Southern Nuclear Operating Company
Vogtle Electric Generating Plant Units 3 and 4
Supplement to Revision to Request for License Amendment and Exemption:
Power Operated Relief Valve (PORV) Noise Mitigation (LAR-18-021R1S1)

7) Vogtle Electric Generating Plant (VEGP) Units 3 and 4 – Supplement to Revision to Request for License Amendment: Power Operated Relief Valve (PORV) Noise Mitigation (LAR-18-021R1S1)

Enclosure 7

(LAR-18-021R1S1)

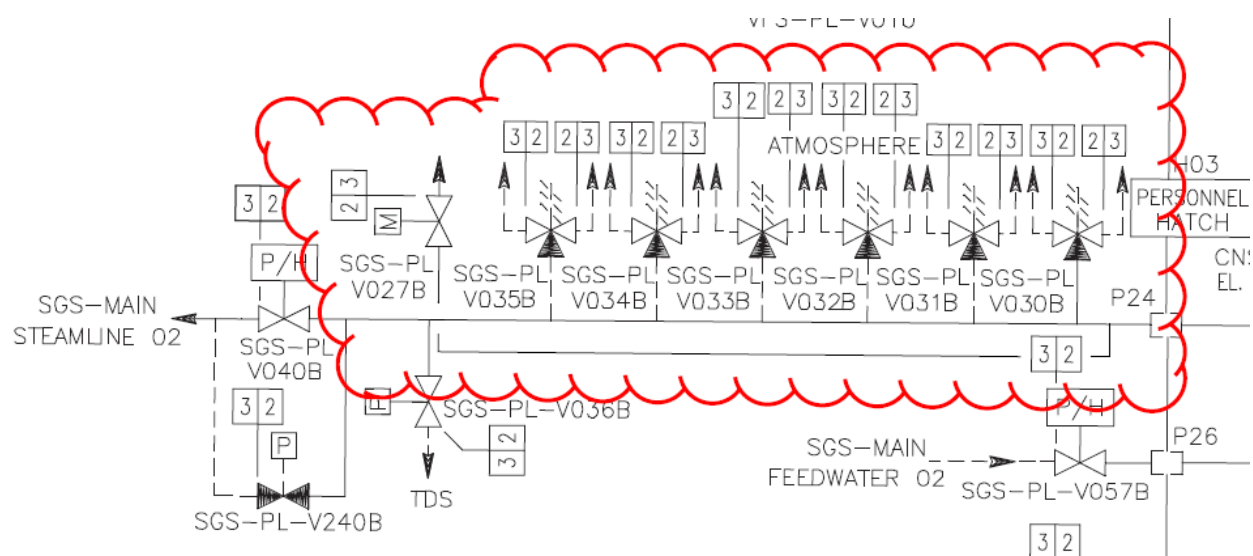
Revise COL Appendix C (and corresponding plant-specific Tier 1) Figure 2.2.1-1, to relocate the branch line to the PORV on SGS–MAIN STEAMLINE 01 as shown below:
